SILVER LAKE DAM.

PHASE I INSPECTION REPORT. NATIONAL DAM SAFETY PROGRAM.

DE 0031

DEPARTMENT OF THE ARMY
PHILADELPHIA DISTRICT, CORPS OF ENGINEERS
CUSTOM HOUSE - 2D & CHESTNUT STREETS
PHILADELPHIA, PENNSYLVANIA 19106
JANUARY 1978

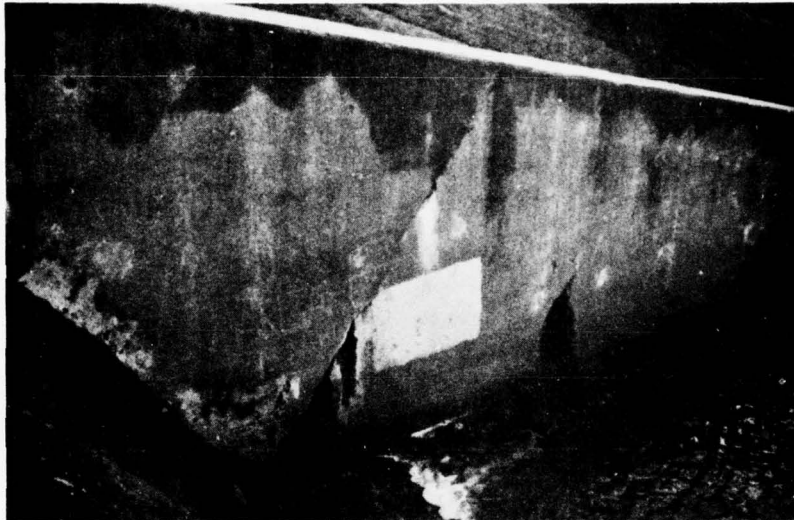
1. 13 Dec 77. Upstream embankment slope behind overflow structure left abutment wall. Note sloughing of embankment, 4" remedial stone, and deteriorating concrete at freeze-thaw line.

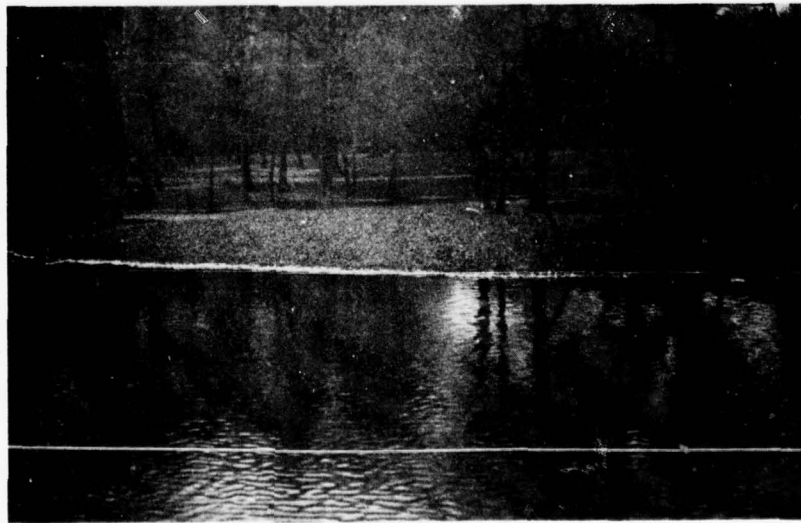
5. 13 Dec 77. Close view of overflow structure left abutment wall showing diagonal cracking with minor leakage, looking southeast from walkway.

6. 13 Dec 77. Longitudinal cracking of overflow structure walkway - fifth bay from left bank.
